Service Bulletin

TAT SB10-02, Revision B

Model SR22 w/ Turbonormalizer

The purpose of this Service Bulletin is to instruct owners of Turbonormalized Cirrus Design SR22 airplanes to have the supplemental tailpipe hangers inspected and replaced.

Installation of left hand tailpipe support bracket

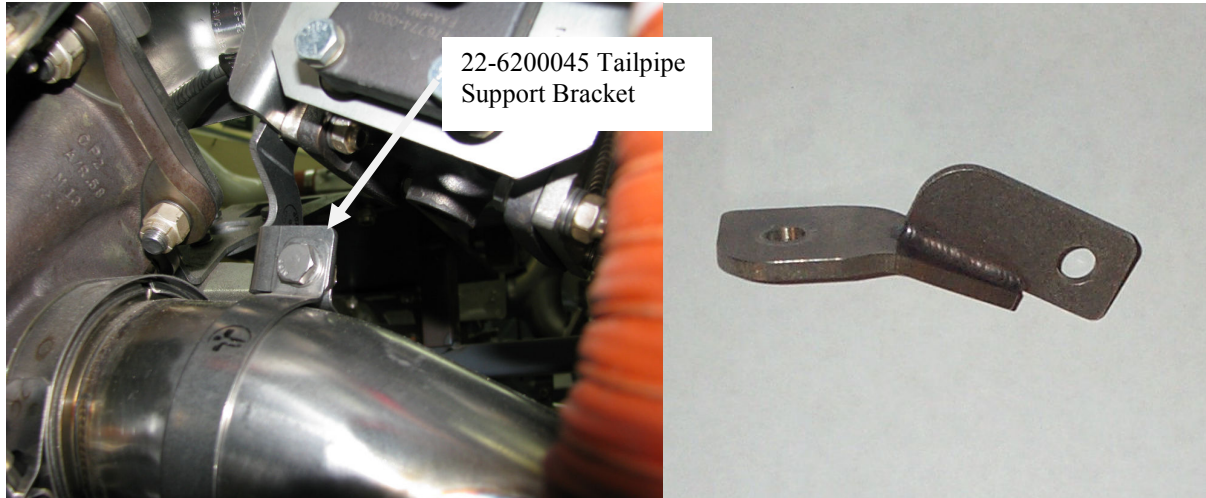
1. Remove cowling.
2. Using a bright flashlight, inspect the left hand tailpipe support bracket that holds the flat band clamp around the left hand tailpipe. If the left hand support bracket is cracked or broken, replace it with a new 22-6200045 bracket in accordance with instructions in this bulletin. Using a bright flashlight, inspect the right hand tailpipe support bracket that holds the flat band clamp around the right hand tailpipe and the exhaust system in the area of the tailpipe support as outlined in the TATI Instructions for Continued Airworthiness, document number 22-6460004. Perform any required maintenance on the right hand exhaust based upon the inspection. If the right hand tailpipe support bracket is attached to the right hand wastegate flange and needs to be removed for any maintenance, replace the bracket with a 22-6200039 bracket at that time in accordance with instructions in this bulletin.

3. To replace the left hand tailpipe bracket remove the existing tailpipe bracket. Install 22-6200045 bracket with existing hardware. Slide flat tailpipe band clamp into position and attach to 22-6200045 bracket with existing hardware. If the locknuts do not continue to show resistance to turning, replace them with new MS21045C4 nuts. Tighten nuts to 70 in-lb.

Installation of right hand tailpipe support bracket on “Generation I” right hand exhaust

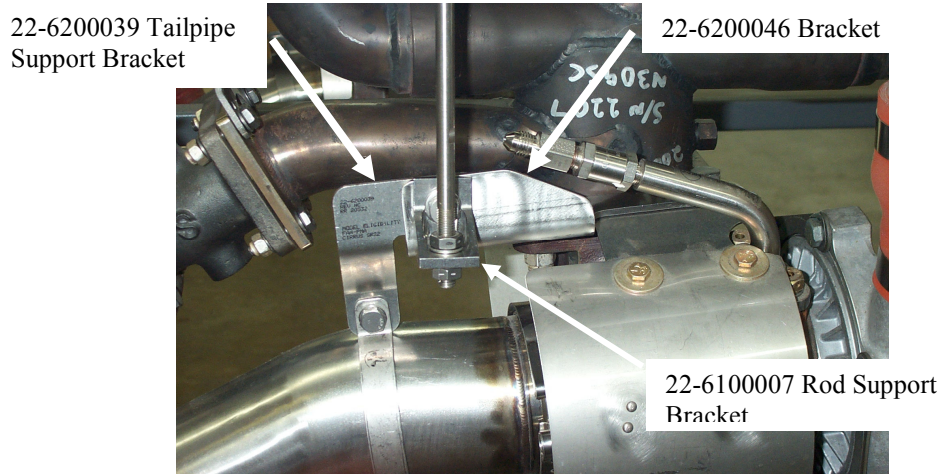
4. (a) For “Generation I” right hand exhaust:
To replace the right hand tailpipe bracket remove the existing tailpipe bracket. Install AN4C11A bolts in place of the bolts removed from the wastegate flange. Tighten nuts to 70 in-lb (if the locknuts do not continue to show resistance to turning, replace them with new MS21045C4 nuts). Cut the safety wire and remove the lower nut holding right hand turbo support rod. Slide the rod up and out of the way to gain access to the bolt holding the lower rod support. Remove the two outboard turbo flange bolts and the lower rod support channel bracket from the turbo flange. Install a 22-6200046 bracket on the outboard portion of the turbo flange on top of the turbo heat shield support with two AN6C13A bolts and existing washers and

nuts. If the nuts do not continue to show resistance to turning, replace them with new MS21045C6 nuts. Tighten MS21045C6 nuts to 275 in-lb. Install a 22-6100007 rod support bracket on the outboard side and a 22-6200039 tailpipe bracket to the inboard side of the 22-6200046 bracket with an AN5C7A bolt. Install washer and locknut. If the locknut does not continue to show resistance to turning, replace it with new MS21045C5 nut. Tighten nut to 180 in-lb after reinstallation and alignment of turbo support rod. Reinstall turbo support rod, verify that rod is properly aligned and tighten lower nut to 100 in-lb. Resafety lower turbo support rod nuts. Slide flat tailpipe band clamp into position and attach to 22-6200039 bracket with existing hardware. If the locknut does not continue to show resistance to turning, replace it with new MS21045C4 nut. Tighten nut to 70 in-lb.

Installation of right hand tailpipe support bracket on
"Generation II" exhaust

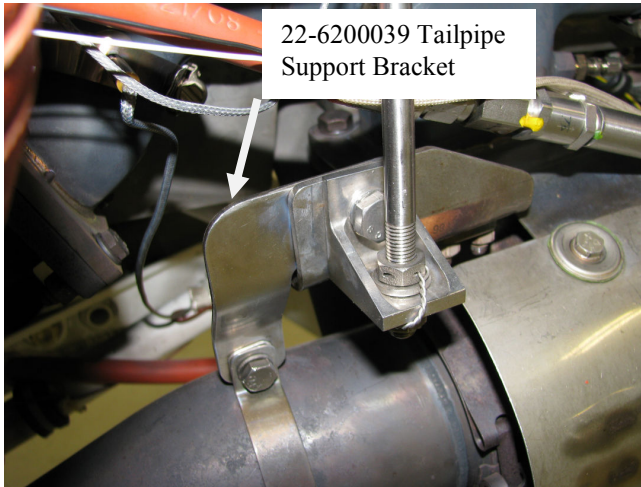
To replace the right hand tailpipe bracket remove the existing tailpipe bracket. Install AN4C11A bolts in place of the bolts removed from the wastegate flange. Tighten nuts to 70 in-lb (if the locknuts do not continue to show resistance to turning, replace them with new MS21045C4 nuts). Cut the safety wire and remove the lower nut holding right hand turbo support rod. Slide the rod up and out of the way to gain access to the bolt holding the lower rod support. Remove the AN5C6A bolt holding the rod support to the angle bracket attached to the turbo flange. Replace the AN5C6A bolt with an AN5C7A bolt. Place a 22-6200039 tailpipe bracket on the inboard side of the angle bracket and install washer and locknut. If the locknut does not continue to show resistance to turning, replace it with new MS21045C5 nut. Tighten nut to 180 in-lb after reinstallation and alignment of turbo support rod. Reinstall turbo support rod, verify that rod is properly aligned and tighten lower nut to 100 in-lb. Resafety lower turbo support rod nuts. Slide flat tailpipe band clamp into position and attach to 22-6200039 bracket with existing hardware. If the locknut does not continue to show resistance to turning, replace it with new MS21045C4 nut. Tighten nut to 70 in-lb.
